Post Accident AP1000 Containment Leakage

**AP1000 Oversight Group
John Runkle
Fairewinds Associates, Inc
Arnie Gundersen**

Peer reviewed by Dr. Rudolf Hausler

AP1000 Normal Operation

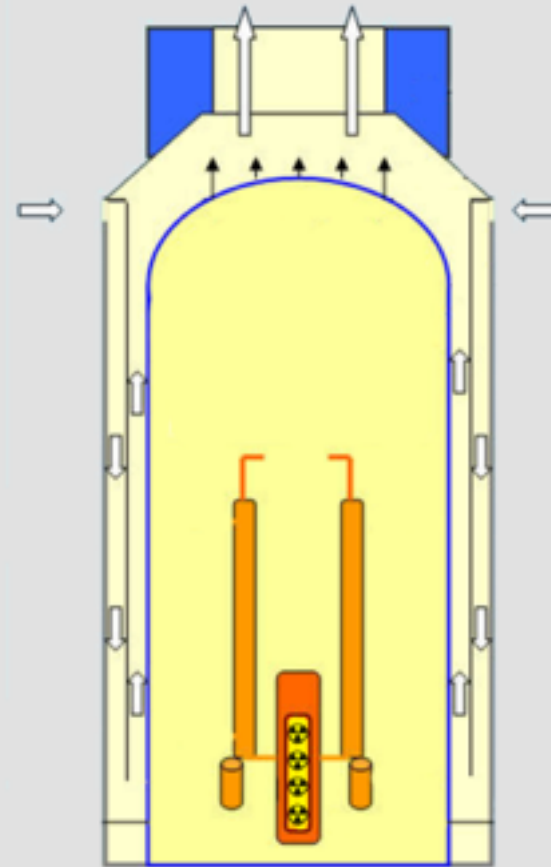
Fairewinds and Hausler have the following concerns with the NRC's analysis:

ASME XI inspection programs have historically missed flaws in the containment.

Application of protective coatings has historically allowed for coating degradation.

Wall-brackets on the outside of the AP1000 containment create crevices that allow for moisture build-up and creates a corrosive environment.

The junction between the wall and the floor creates a crevice that allows for moisture build-up and creates a corrosive environment.

The shield building breathes in moist outside air containing contaminants that can be deposited in crevices and cause corrosion.

Hausler estimates corrosion rates as fast as 0.15 inches per year.

AP1000
Chimney Effect
Draws
Radioactivity
Directly Into The
Environment

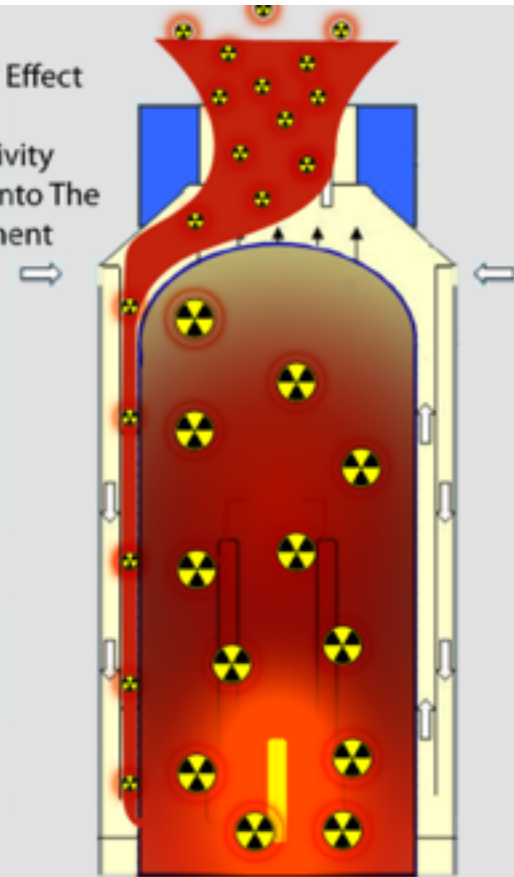
Westinghouse considers an Intact Containment “... to be within the design basis of the containment...”

“This is the ‘no-failure’ containment failure mode and it’s termed intact containment. The main location for fission/product leakage from the containment is penetration leakage into the auxiliary building...”

For its SAMDA analysis, Westinghouse assumes a late containment failure (CLF), a failure of the containment to isolate (CI), and bypass through an open piping system (BP).

For the CLF, CI, and BP scenarios, Westinghouse assumes that containment leakage is into other filtered areas of the plant and is not released directly into the environment.

AP1000
Chimney Effect
Draws
Radioactivity
Directly Into The
Environment

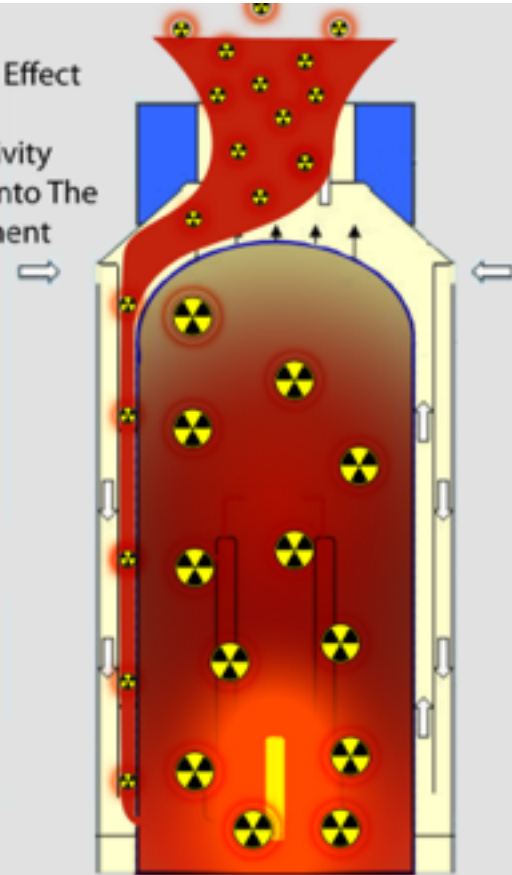
Both Westinghouse and the NRC assume that ASME XI inspections and protective coatings applied to the outside of the AP1000 containment will reduce the risk of a pinhole leak to **ZERO**.

Fairewinds analysis of 40-years of problems associated with the integrity of containment shows there is a relatively high probability of a pinhole leak in the AP1000 containment.

Should this pinhole leak exist, post accident pressures of 50-psi inside the containment will push radioactive gases into the annular gap causing off-site doses to exceed 10 CFR 100 allowable exposure levels.

AP1000
Chimney Effect
Draws
Radioactivity
Directly Into The
Environment

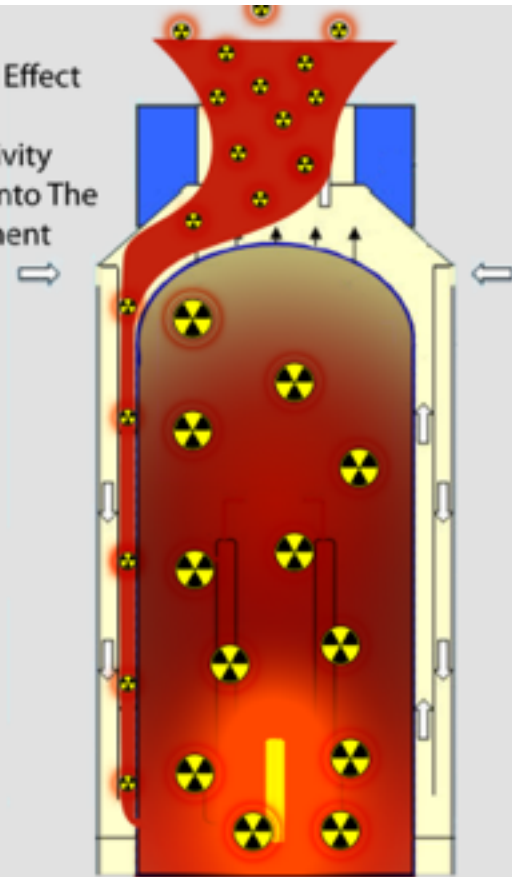
Westinghouse has already analyzed and then discarded the option of filtered ventilation.

“Secondary Containment Filtered Ventilation... The passive filter system is operated by drawing a partial vacuum on the middle annulus through charcoal and HEPA filters...the secondary containment would then reduce fission product release from any containment penetration.”

Even this proposed option does not completely eliminate Fairewinds’ concerns as leakage into the annular gap through a pinhole leak in the containment wall might not be captured.
